Subject: NRC RAI dated March 10, 2010, Certificate of Compliance No. 9263

Source Production & Equipment Co., Inc.

ADDITIONAL INFORMATION PER NRC REQUEST FOR SPEC-150, CERTIFICATE 9263

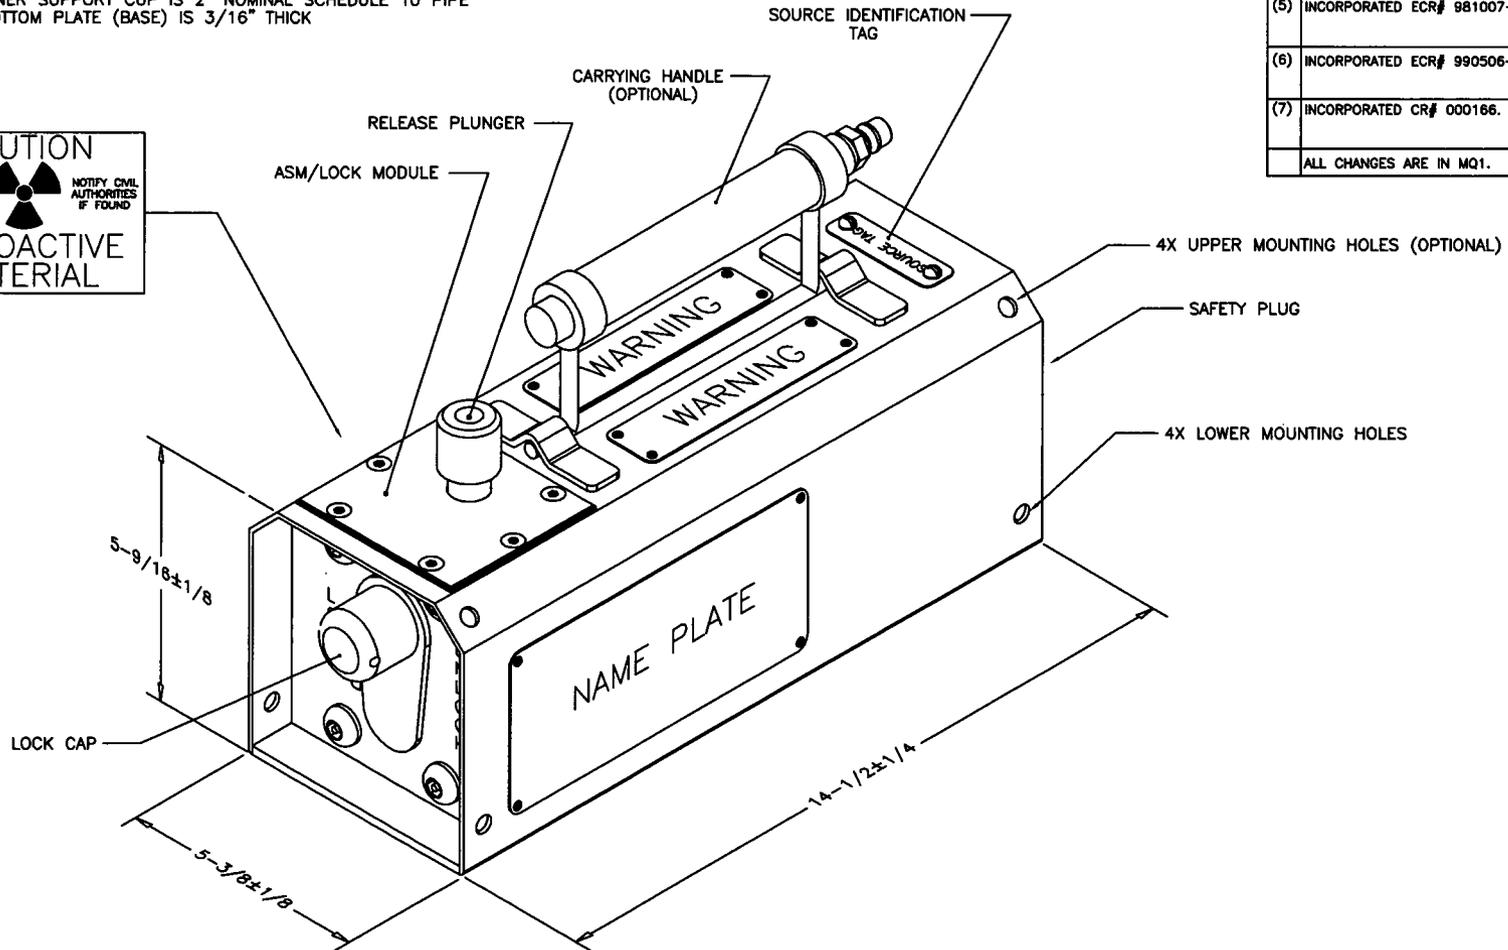
Drawing	Rev	Description of Changes from Current Certificate
15B000	9	Removed fabrication and inspection notes, they are now described on 15B002A. Added supplemental shielding note from 15B008 rev 5, added maximum weight and materials from 15B002A rev 6. Added note to see SAR for material specifications for serial number 1475 and newer.
15B002A	8	Added fabrication and inspection notes for ITS and non-ITS welds, added material specifications for safety related components for serial number 1475 and newer.
15B008	7	Removed notes that did not specifically describe the depleted uranium shield. Added minimum weight and density for serial number 1475 and newer.
19B005	2	Added material specifications for safety related components for serial number 1475 and newer, the source assembly lock, device lock, lock module housing and lock module faceplate.
19B006	2	Added material specifications for safety related components for serial number 1475 and newer, the source assembly lock and device lock.

- SUPPLEMENTAL SHIELDING, IF NEEDED TO MEET NORMAL CONDITION DOSE RATE LIMITS, IS ATTACHED TO THE SHIELD OR OTHER PACKAGE COMPONENTS USING ALUMINUM EPOXY POTTING COMPOUND. THE SUPPLEMENTAL SHIELDING CONSISTS OF ONE POUND OR LESS OF DEPLETED URANIUM, TUNGSTEN OR LEAD.
- MAXIMUM WEIGHT: 53.5 LBS.
- SEE SAR FOR MATERIAL SPECIFICATIONS FOR SERIAL NUMBERS 1475 AND NEWER. HOUSING COVER IS 3/32" THICK
OUTLET END SUPPORT CUP & BULKHEADS ARE 1/8" THICK
INNER SUPPORT CUP IS 2" NOMINAL SCHEDULE 10 PIPE
BOTTOM PLATE (BASE) IS 3/16" THICK

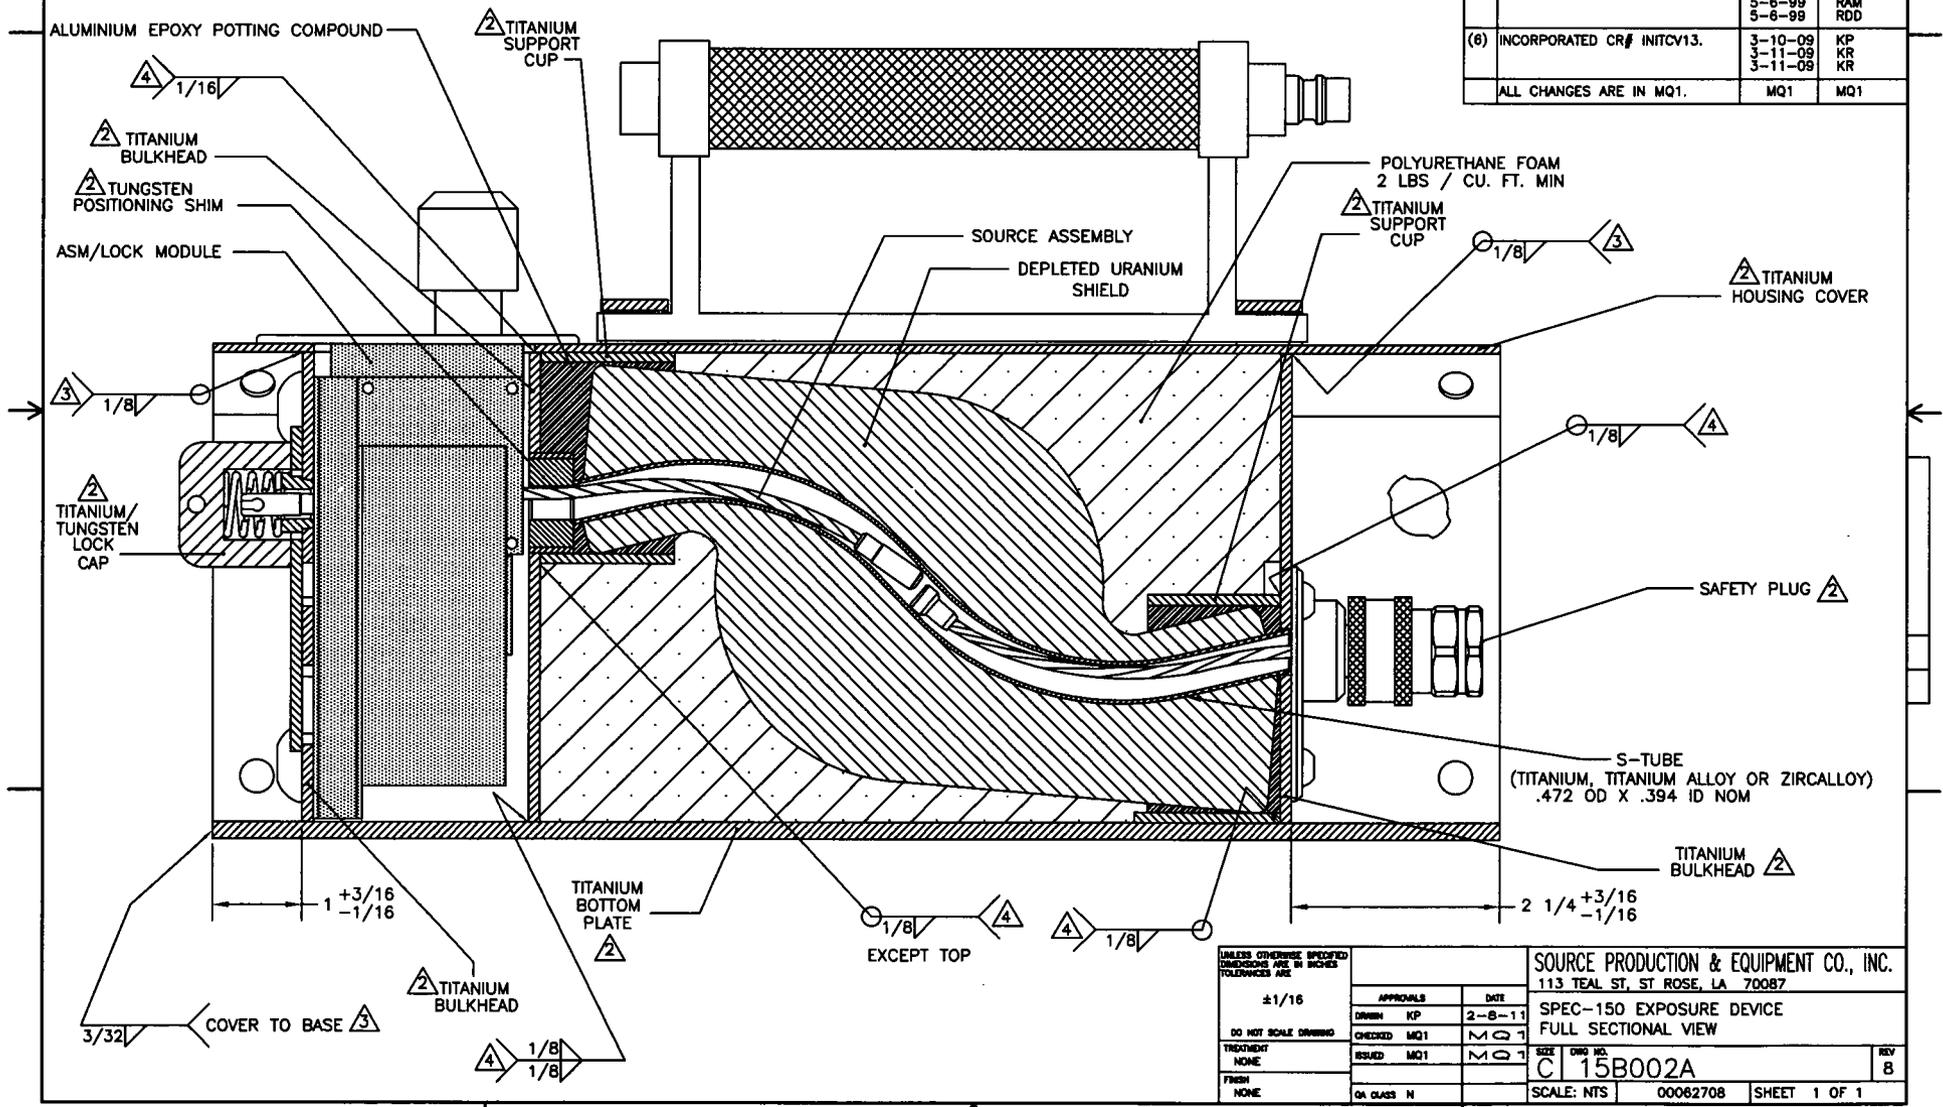
RAI	SPEC's Position / Response
<p>1 Specify which joins are structural and which are non-structural on the licensing drawings. The licensing drawings should unambiguously describe the welds on the package.</p>	<p>Drawing 15B000 contained notes describing the welding and inspection for "structural joints". These notes were removed from 15B000, and added to drawing 15B002A which depicts both Important to Safety (ITS) and non-ITS welds. The welding and inspection specifications for each weld are described on the drawing with arrows pointing to each weld. See Appendix A for revised drawings.</p>
<p>2 Clarify why internal structural joins do not undergo dye-penetrant testing.</p>	<p>The internal welds are not ITS welds. The internal welds are not 360 degree welds, they don't attach the bulkheads to the housing all the way around, the outer bulkhead welds do. They function as a construction aid by holding the internal components in position for the external 360 degree welds. Therefore, the primary reason to perform a visual weld inspection of the internal welds is to detect warpage, misalignments, adverse affects on the base weld material, improper fit up, and other unacceptable weld attributes.</p> <p>The outer 360 degree welds that attach the bulkheads to the housing are dye penetrant tested.</p>

<p>3 Citing a standard industrial code, specify that all thermal metal joins will be examined. State the examination methodologies and the acceptance criteria used in the weld fabrication by citing a standard industrial code.</p>	<p>Drawing 15B002A was revised to point to each specific weld and specify the corresponding inspection method depending on whether the weld is important to safety. Drawing notes were added as follows:</p> <ul style="list-style-type: none"> - This important to safety (ITS) weld is fabricated and liquid penetrant inspected in accordance with ASME Section VIII, Division I, or, fabricated and inspected in accordance with AWS D1.9. - This weld is not ITS, and is fabricated and visually inspected in accordance with ASME Section VIII, Division I, or, fabricated and visually inspected in accordance with AWS D1.9. <p>See Appendix A for revised drawings.</p>
<p>3 Ensure that Section 8.1.2 of the application is consistent with the licensing drawings.</p>	<p>Section 8.1.2 was revised to be consistent with the above RAI response. See Consolidated SAR and Appendix C.</p>

<p>4 Specify ASME code of construction (e.g., Section VIII, Division I) which is used as the basis for welding for thermal metal joins on the package.</p>	<p>Welds are performed in accordance with the applicable requirements of ASME Section VIII, Division I using procedures and welders qualified in accordance with ASME Section IX. We plan to transition both fabrication and welding to the AWS D1.9 code later. See Appendix A for revised drawings.</p>

RAI	SPEC's Position / Response
5	Clarify why the ASTM E-165 is used as the basis for the examination procedures of thermal metal joints on the package, and not Section V of the ASME code.	The statement on drawing 15B002A has been revised to state that dye penetrant weld examinations are performed in accordance with ASME Section VIII, Division I. ASME Section V, Article 24 covers Liquid Penetrant Standards, and includes SE-165 (which states that it is identical to ASTM E 165).
6	Specify a standard industrial code, e.g., ASTM or ASME, which mandates the minimum mechanical properties and level of fabrication quality for all materials used to construct components that are safety-related, with the exception of zirconium and depleted uranium alloys.	The drawings were revised by adding a note stating "See SAR for Material Specification for serial number 1475 and newer". We have included Appendix D in the consolidated SAR listing the material specifications for materials related to package safety, with the exception of zirconium and depleted uranium alloys. The depleted uranium shields are surveyed to ensure that they shield properly. They are described in the drawings as being at least 99% pure, with a minimum density of 18.3 g/cc, and weight of 35 to 37 1/4 pounds. See Appendix A for revised drawings and Appendix D for material specifications.

1. REMOVED.
- ② SEE SAR FOR MATERIAL SPECIFICATIONS.
- ③ IMPORTANT TO SAFETY (ITS) WELDS ARE FABRICATED AND LIQUID PENETRANT INSPECTED IN ACCORDANCE WITH THE APPLICABLE REQUIREMENTS OF ASME SECTION VIII, DIVISION I, OR, FABRICATED AND INSPECTED IN ACCORDANCE WITH AWS D1.9.
- ④ THIS WELD IS NOT ITS, AND IS FABRICATED AND VISUALLY INSPECTED IN ACCORDANCE WITH ASME SECTION VIII, DIVISION I, OR, FABRICATED AND VISUALLY INSPECTED IN ACCORDANCE WITH AWS D1.9.
5. NOTES 2,3,4 ARE APPLICABLE TO SPEC-150 SERIAL NUMBERS 1475 AND NEWER.

UNLESS OTHERWISE SPECIFIED DIMENSIONS ARE IN INCHES TOLERANCES ARE:	
±1/16	
DO NOT SCALE DRAWING	
TREATMENT	NONE
FINISH	NONE
APPROVALS	DATE
DRAWN KP	2-8-11
CHECKED MQ1	MQ1
ISSUED MQ1	MQ1
QA CLASS N

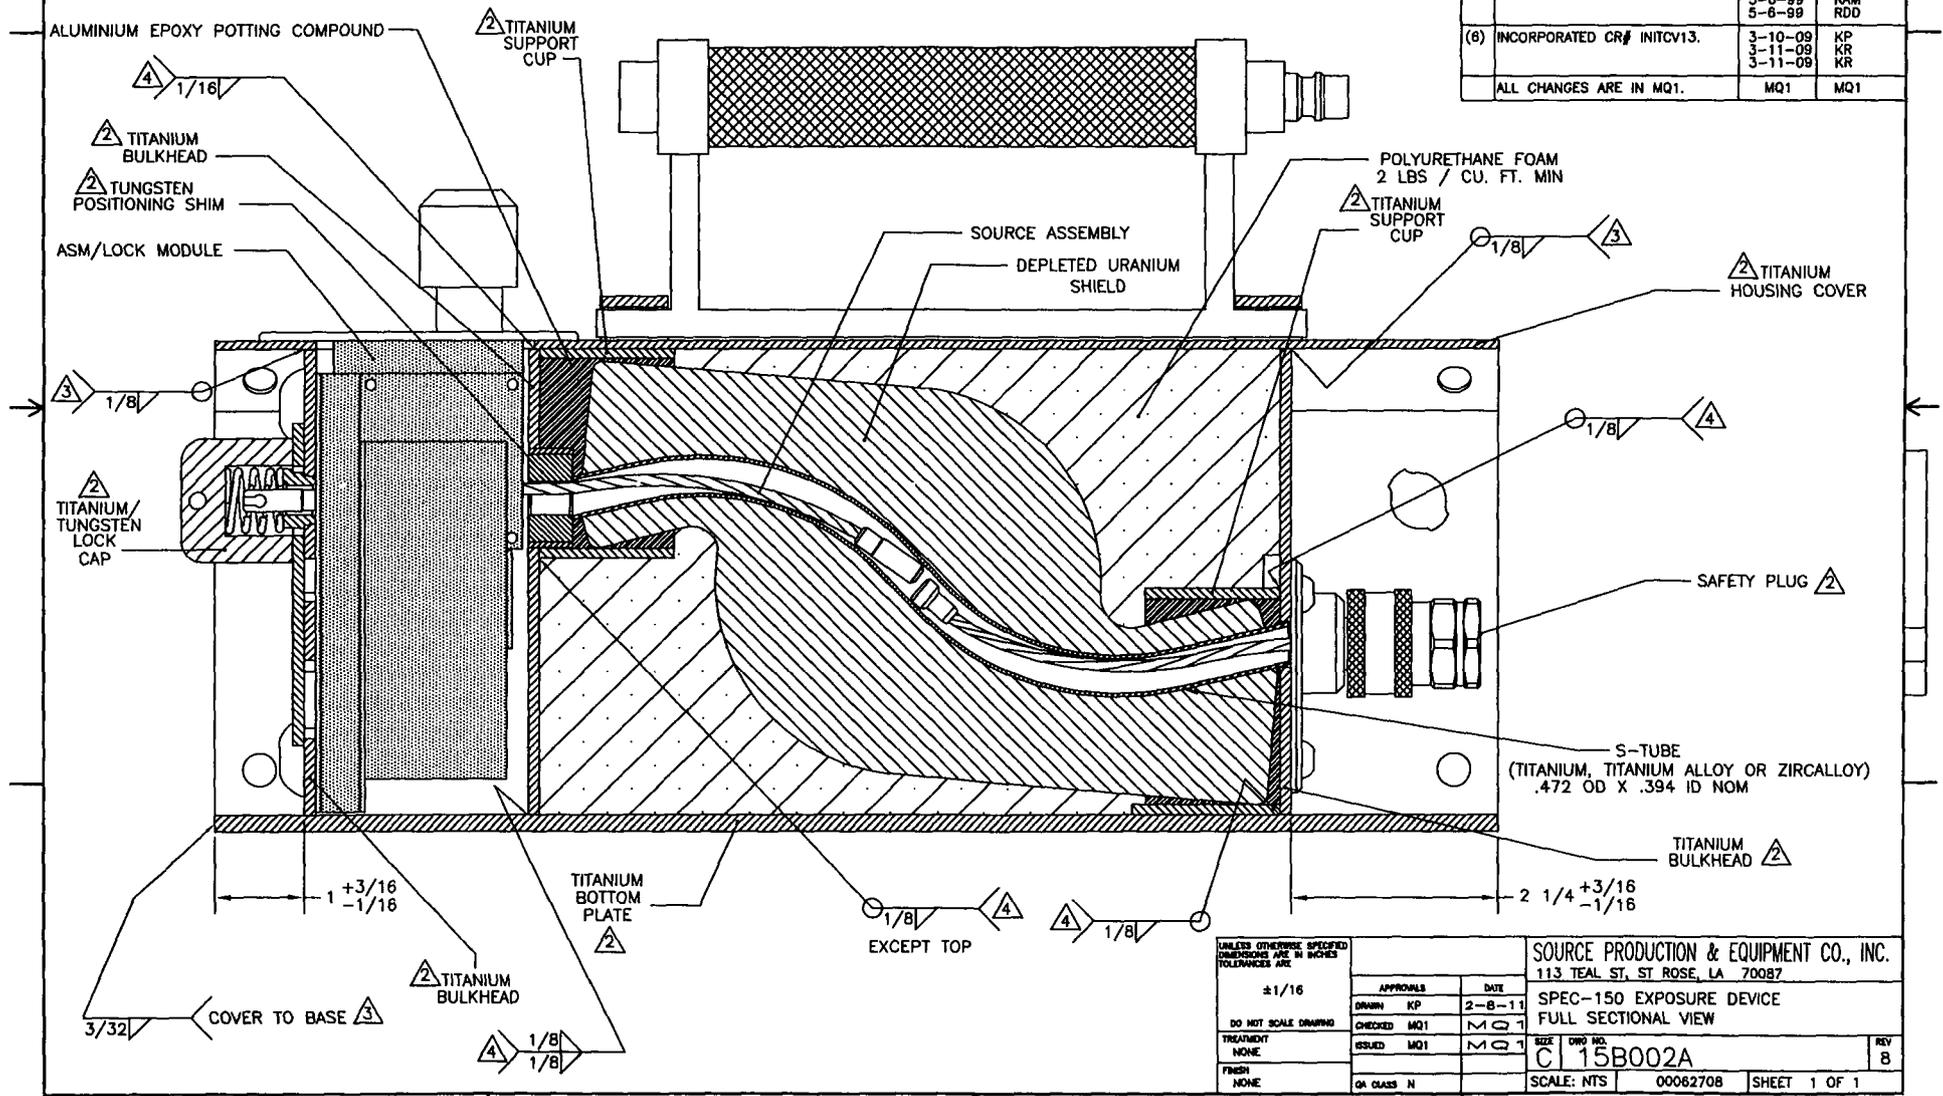
7.1.1	Add check of fasteners, see RAI-9.		Add: Visually check the exposed fasteners and welds.
8.1.2	Change terminology from critical structural to important to safety with reference to the weld joints. Add reference to drawing 15B002A for a depiction of welds. Describe the weld joints that are visually inspected. Clarify that liquid penetrant inspections include a visual inspection.	. . . on critical structural joints. All exterior TMJ thermal metal joining structural joints are liquid penetrant tested. The method of inspection of the production packages will consist of a combination of in-process and final inspection of all structural TMJ weld joints that connect the titanium plates. Dye penetrant inspection is performed on the joints that comprise the basic structure of the package which consists of the housing cover (shell), bottom plate and both end plates.	. . . on important to safety weld joints. See drawing 15B002A which depicts specific inspection method used for specific SPEC-150 welds. Visual inspection is performed on the welded joints that connect the inner bulkhead plate to the bottom plate, the inner bulkhead support cup to the inner bulkhead, and the outlet end plate support cup to the outlet end plate and bottom plate. Both visual and liquid penetrant inspection is performed on the joints that comprise the basic structure of the package which consists of the housing cover (shell), bottom plate and both end plates.

#	Change	Text was:	Is:
8.1.2	Describe inspection codes that will be used, the same code will be used for inspections that is used for the welding. Move statement on where visual inspection is performed to the beginning of the section.	Dye penetrant inspection and inspector qualification is performed in accordance with ASTM E-165. The accept/reject criteria meets ASME Section VIII, Division 1, "Rules for Construction of Pressure Vessels" Appendix 8, Paragraph 8.3 "Evaluation of Indications" and 8.4 "Acceptance Standards." Visual inspection is performed on the TMJ joints that connect the inner bulkhead plate to the bottom plate, the inner bulkhead support cup to the inner bulkhead, and the outlet end plate support cup to the outlet end plate and bottom plate. Visual inspection and inspector qualification is performed in accordance with ASME Section V, "Nondestructive Examination" Article 9, "Visual Examination." The accept-reject criteria meets ASME Section VIII, Division 1, "Rules for Construction of Pressure Vessels" UW-36 "Fillet Welds."	Visual and Liquid Penetrant inspections are performed in accordance with the same code as that used for welding, either the ASME Code for Boilers and Pressure Vessels, Section VIII, Division 1 or AWS D1.9. In either case, either the 2007 edition or an updated revision will be used.

1. REMOVED.
2. SEE SAR FOR MATERIAL SPECIFICATIONS.
3. IMPORTANT TO SAFETY (ITS) WELDS ARE FABRICATED AND LIQUID PENETRANT INSPECTED IN ACCORDANCE WITH THE APPLICABLE REQUIREMENTS OF ASME SECTION VIII, DIVISION I, OR, FABRICATED AND INSPECTED IN ACCORDANCE WITH AWS D1.9.
4. THIS WELD IS NOT ITS, AND IS FABRICATED AND VISUALLY INSPECTED IN ACCORDANCE WITH ASME SECTION VIII, DIVISION I, OR, FABRICATED AND VISUALLY INSPECTED IN ACCORDANCE WITH AWS D1.9.
5. NOTES 2,3,4 ARE APPLICABLE TO SPEC-150 SERIAL NUMBERS 1475 AND NEWER.
